**TREE IMPACT STATEMENT:
Lot 6, Garfield Road East, Riverstone NSW**

This letter has been commissioned by Orion Consulting Engineers to reiterate the impacts to a row of trees located within an area of proposed civil works. The subject trees had been included within an earlier Arboricultural Impact Appraisal and Method Statement (Revision A) compiled by Naturally Trees dated 21 June 2021. This letter is to be read in conjunction with this earlier report, which provides preliminary information on dimensions and protection of the subject trees.

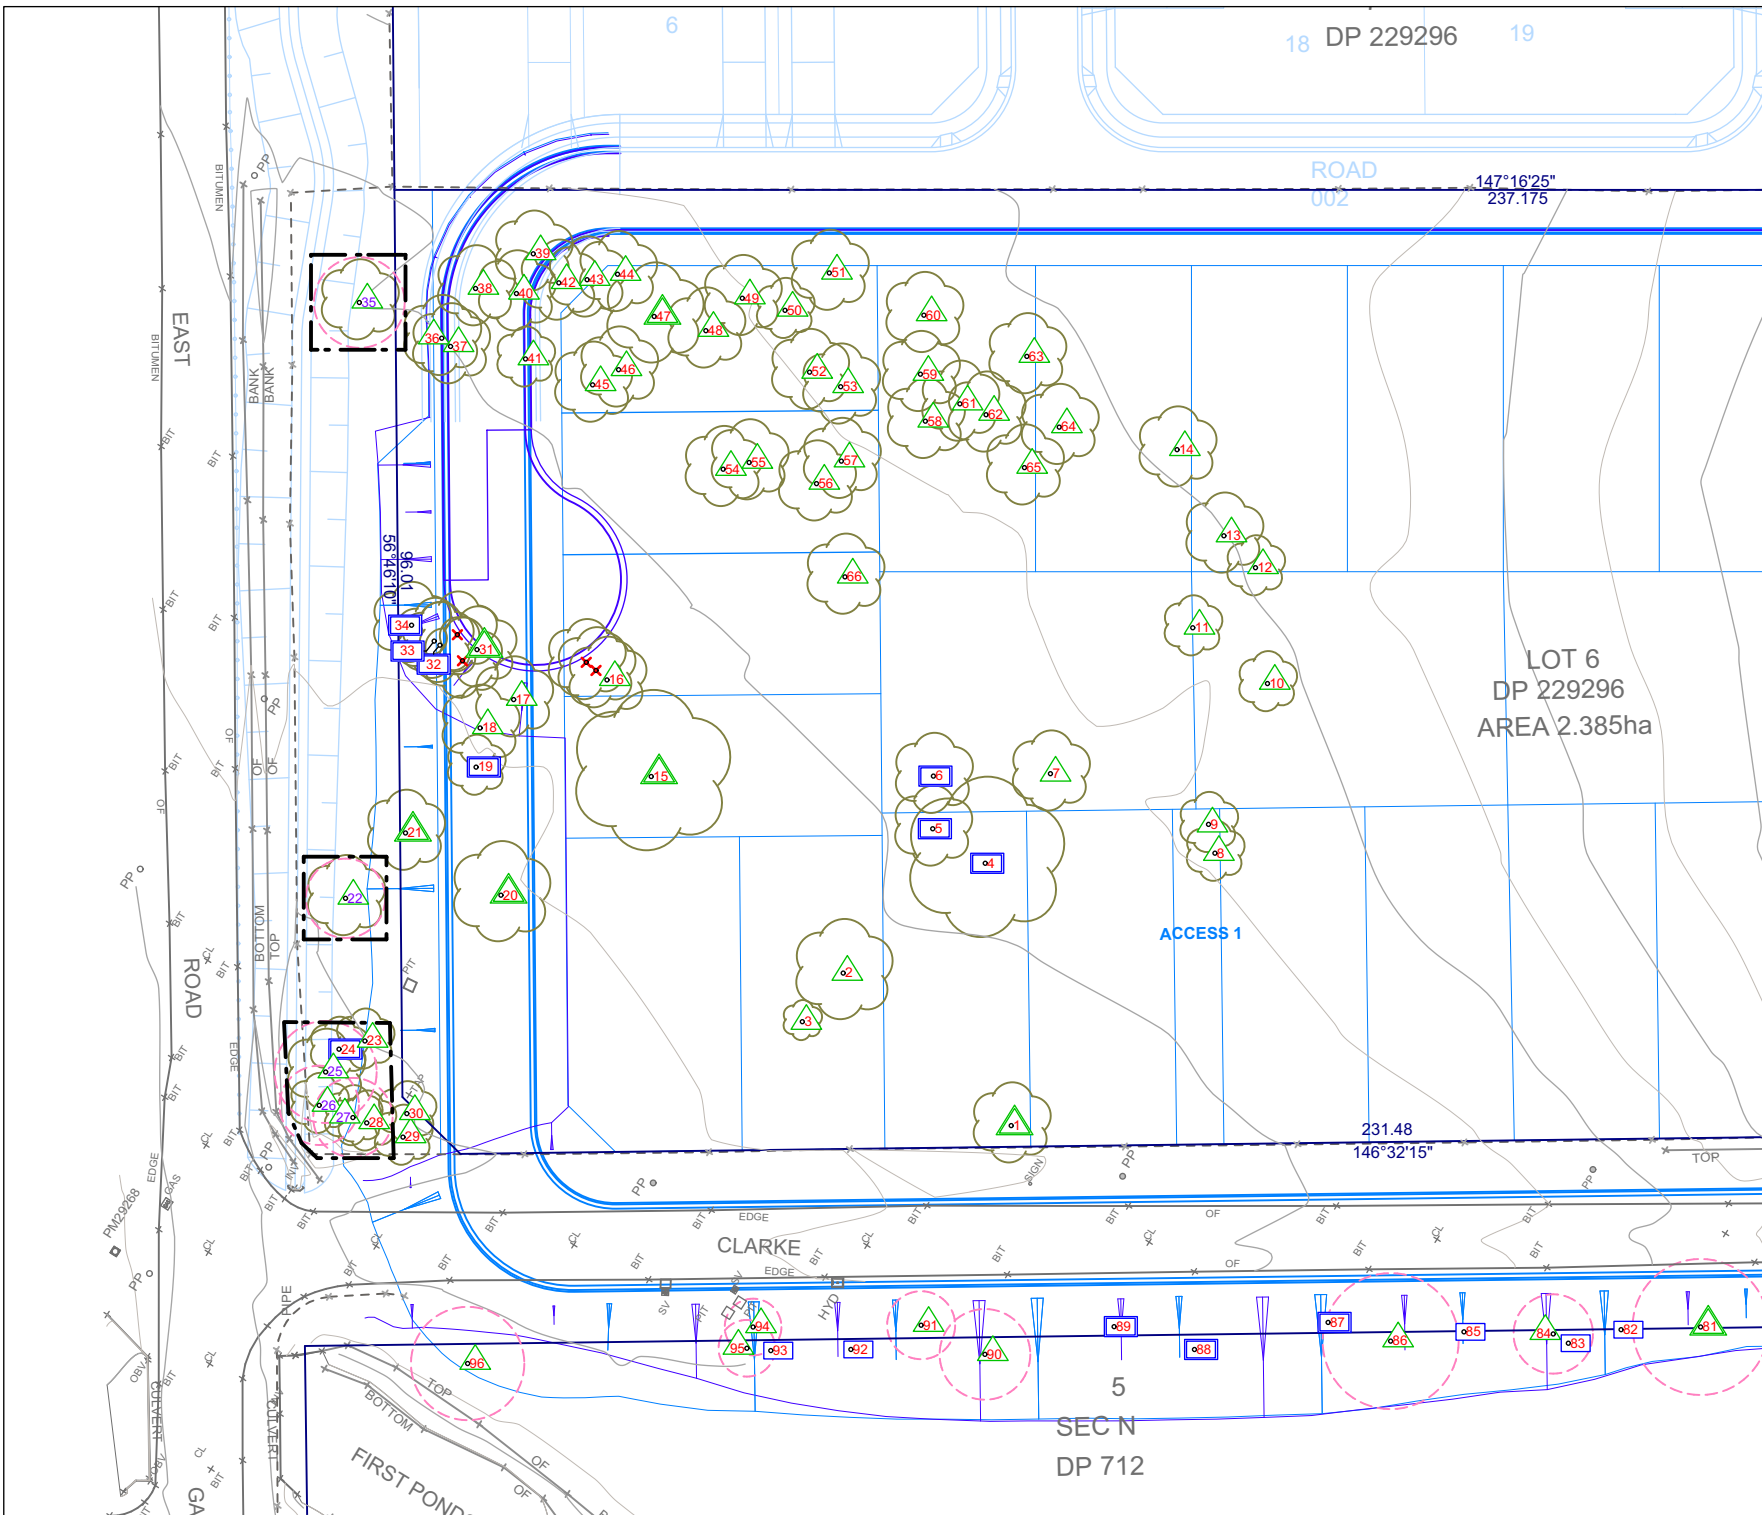
The subject trees, Trees 77 and 79 to 96, are located to the western side of Clarke Street. As per our previous report, these trees vary in retention value with Trees 80, 81, 84, 86, 90, 91, 94, 95 and 96 having the highest retention values. These trees are indigenous species that have very low tolerance to environmental changes.

The proposed civil works includes the widening of Clarke Street and re-levelling of the road batter. The civil works will impact directly within the tree protection zone (TPZ) and structural root zone (SRZ). The following activities within a TPZ will cause significant long-term impacts:

- Excavation, compaction or disturbance of the existing soil.
- The movement or storage of materials, waste or fill.
- Soil level changes
- Movement or machinery, equipment or vehicles.
- Any activity likely to damage the trunk, crown or root system.

To conclude, the proposed civil works will have detrimental impacts on the longevity of Trees 77 and 79 to 96.
